SUBJECT: FAP Route 310 (US 67)
Project NHPP-9TKX(426)
Section 28W-2,29W-1;28RS-6,29RS-4
Warren County
Contract No. 68B60
Item No. 34, November 7, 2025 Letting
Addendum A

NOTICE TO PROSPECTIVE BIDDERS:

Figure 1

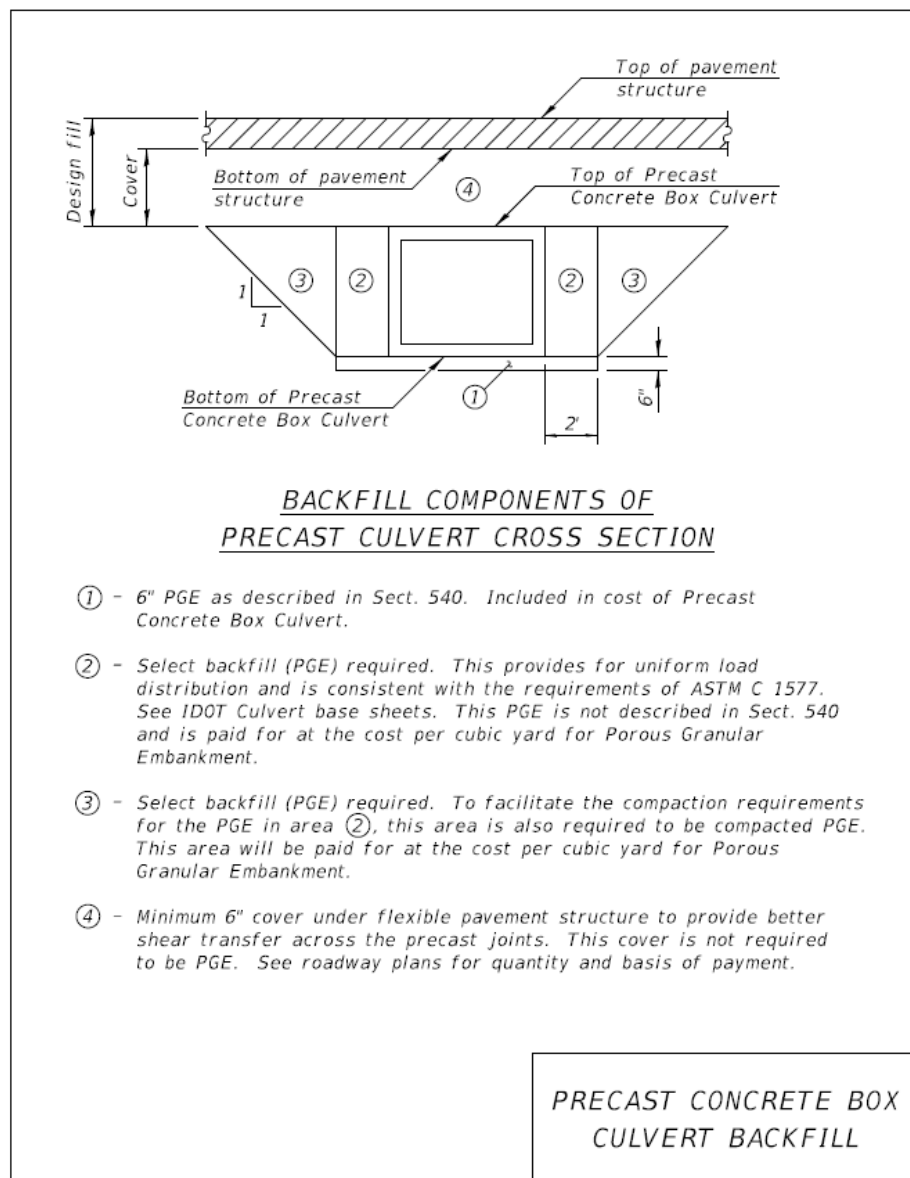
Porous Granular Embankment shall be installed according to Figure 1 included below for Structures 094-2017 (double 10'x10' precast box) and 094-2018 (double 10'x 8' precast box). This work shall consist of all material, labor, equipment, additional excavation and its removal, for the installation of porous granular embankment in accordance with Section 540 of the Standard Specifications, ABD Memo 21.1, and as stated herein.

This work shall not be paid for separately but shall be considered included in the contract unit price per cubic yard for POROUS GRANULAR EMBANKMENT. An additional quantity has been calculated and included in the Summary of Quantities.
